AGENDA

CITY OF OPELIKA
HISTORIC PRESERVATION COMMISSION
September 8, 2022
4:30 p.m.
Meeting Chambers at Opelika Municipal Courtroom
300 MLK Boulevard

City of Opelika
Historic Preservation Commission
Staff Report

Agenda Item #: 2
Meeting Date: 9/08/22
Action Requested: COA: Exterior Renovations; Demo Garage
Location of Property: **807 Geneva St; Geneva Historic District**
Petitioner: Katy Doss

Proposed Signage:

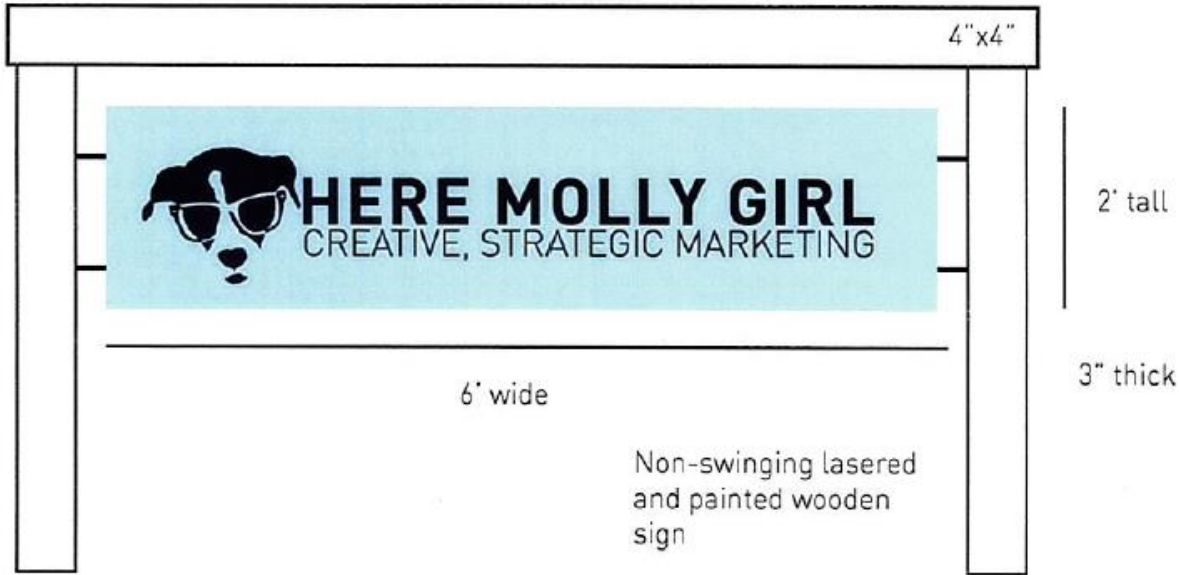
Proposed wood door

proposed lights

Option 1

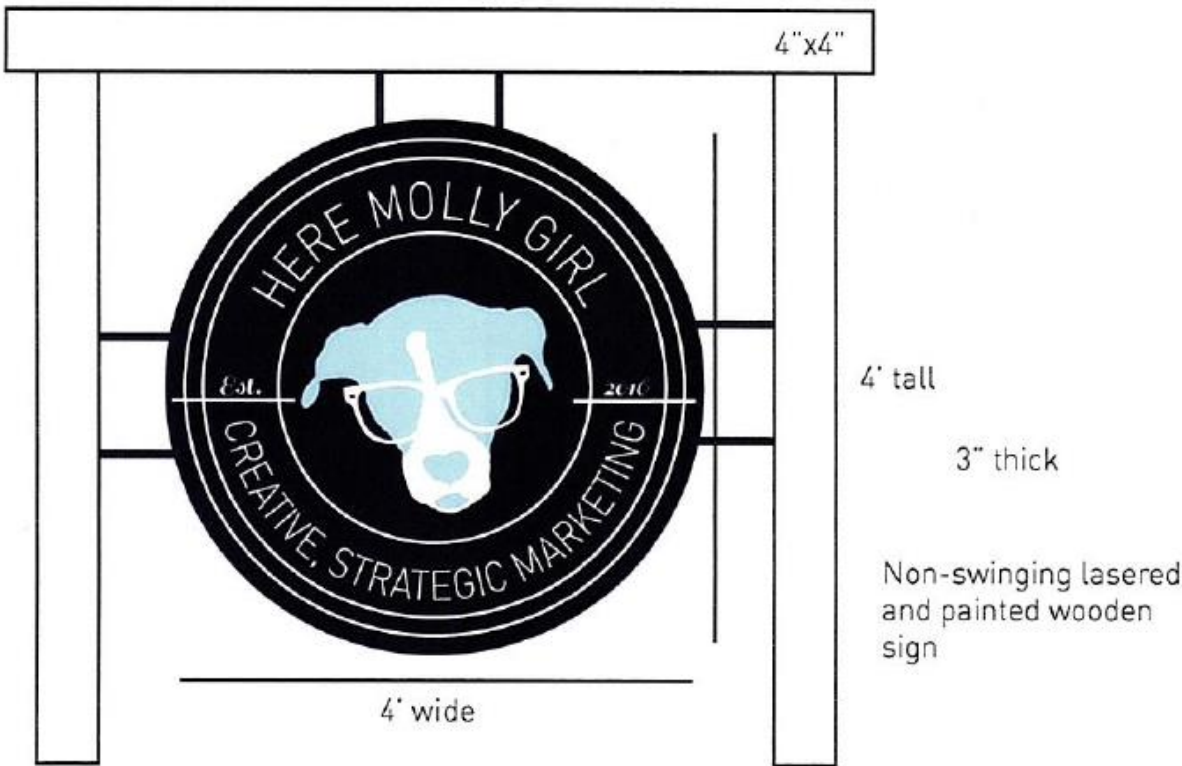
1. Remove existing vinyl siding and replace with cementitious siding with 5" reveal. Install pre-finished metal fascia and perforated cement board soffit to match siding.
2. Replace existing wood door with new wood door. Install new exterior light fixtures on each side of door.
3. Demolish garage.
4. Install non-swinging lasered and painted wood sign with wood posts approximately 5'4"H. Option 1 is rectangular and measures 2'h x 6'w (33SF). Option 2 is circular and measures 4' (22SF).

Right side porch removed

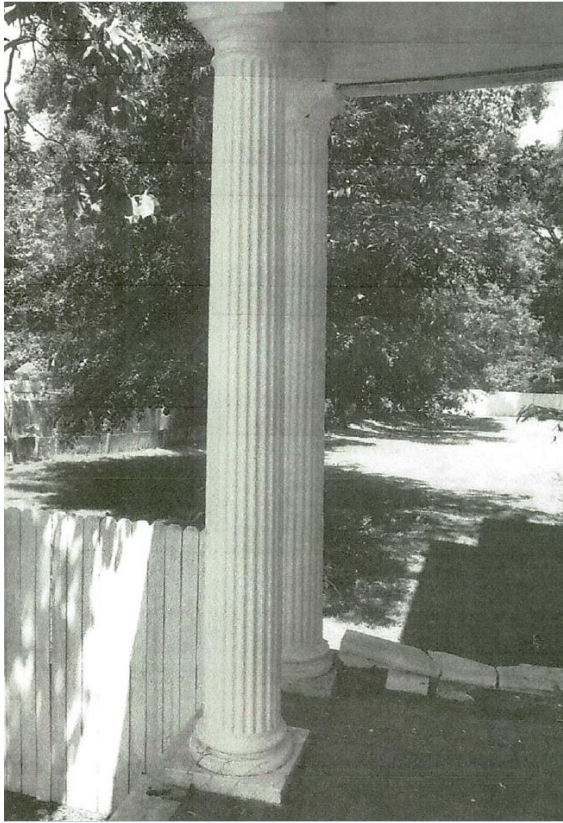
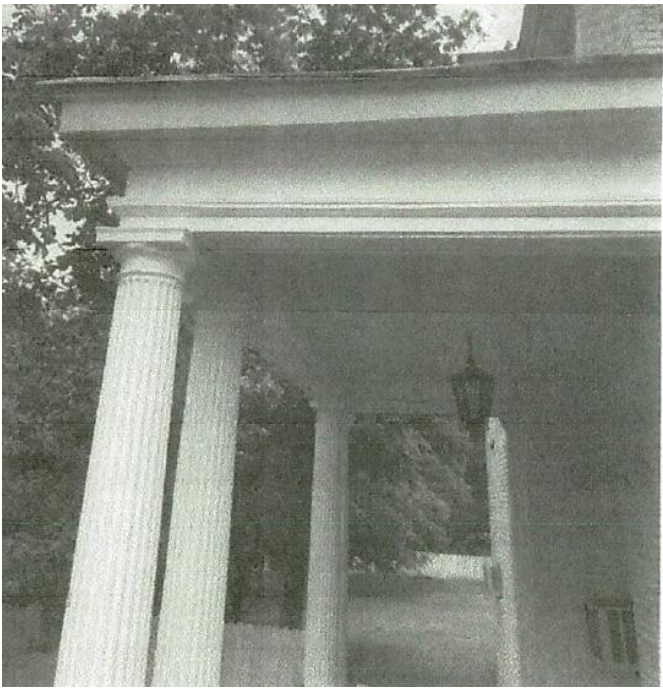
Columns on left side porch

Details of pilaster on left elevation

1. Staff recommends approval of rebuild of side porch with fiberglass columns and materials specified to duplicate left porch.

Rear yard parking

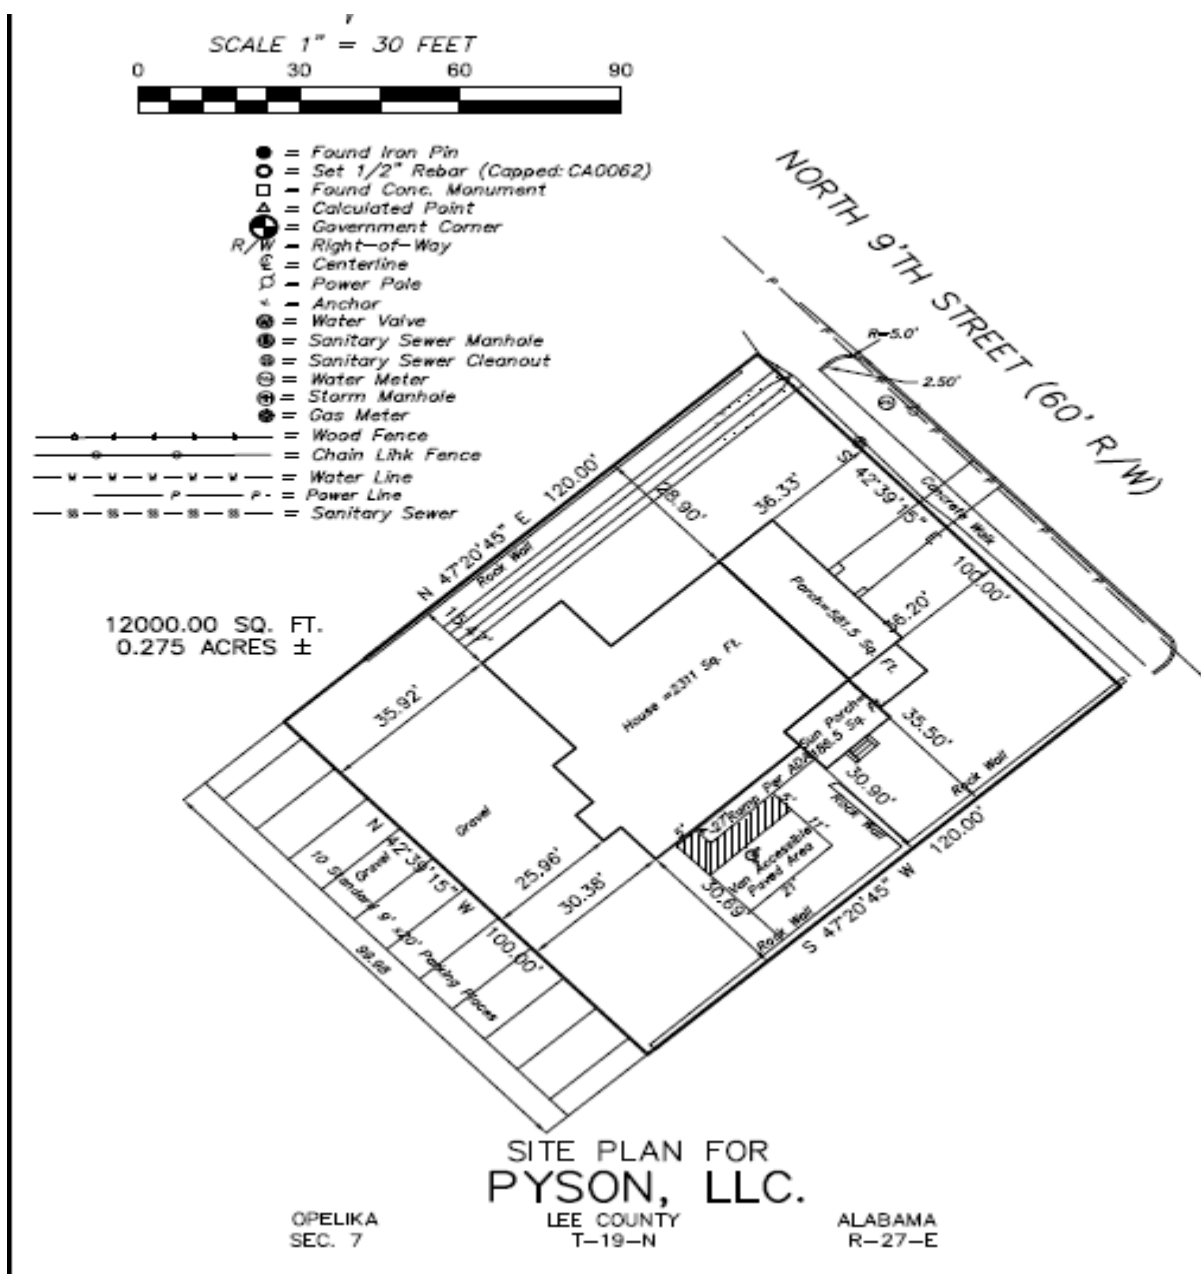
- 1. Install up to ten (10) parking spaces of gravel in rear and one (1) handicap space of concrete with wood handicap ramp onto side porch. Handicap space will be screened behind rock wall currently in place.

1. Staff recommends approval of parking plan meeting all guidelines.
2. Parking Plan is contingent on letter from adjoining property owner giving assess to lot.
